Reference: C.N.172.2001.TREATIES-1 (Depositary Notification)

REGULATION NO. 96. UNIFORM PROVISIONS CONCERNING THE
APPROVAL OF COMPRESSION IGNITION (C.I.) ENGINES TO BE INSTALLED
IN AGRICULTURAL AND FORESTRY TRACTORS WITH REGARD TO THE
EMISSIONS OF POLLUTANTS BY THE ENGINE

TRANS/WP.29/759
20 December 2000

DRAFT 01 SERIES OF AMENDMENTS TO REGULATION No. 96

Model A

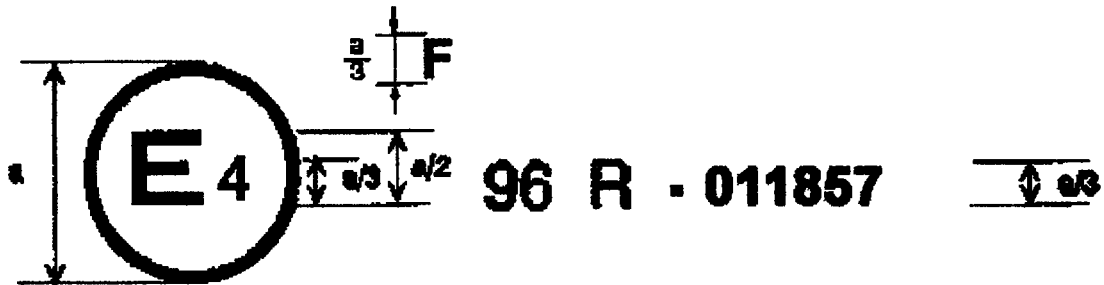
Annex 3, amend to read:

The above approval mark affixed to an engine shows that the engine type concerned has been approved in the Netherlands (E4) pursuant to Regulation No. 96 (according to the level corresponding to power band F) and under approval number 011857. The first two digits of the approval number indicate that Regulation No. 96 was in its amended form (01 series of amendments) when the approval was granted.

Model B

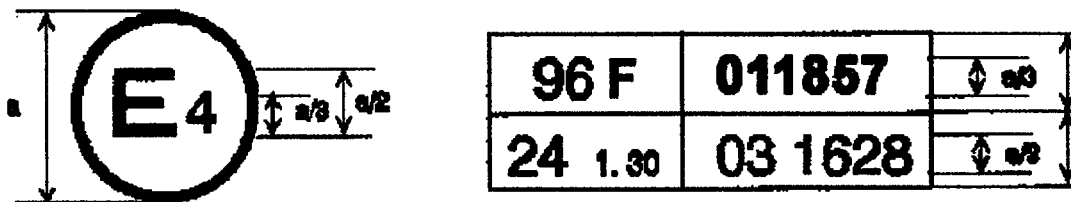
The above approval mark affixed to an engine shows that the engine type concerned has been approved in the Netherlands (E4) pursuant to Regulations Nos. 96 (according to the level corresponding to power band F) and 24. The first two digits of the approval number indicate that, at the dates when the respective approvals were granted, Regulation No. 96 was already in its amended form (01 series of amendments) and Regulation No. 24 already included the 03 series of amendments."
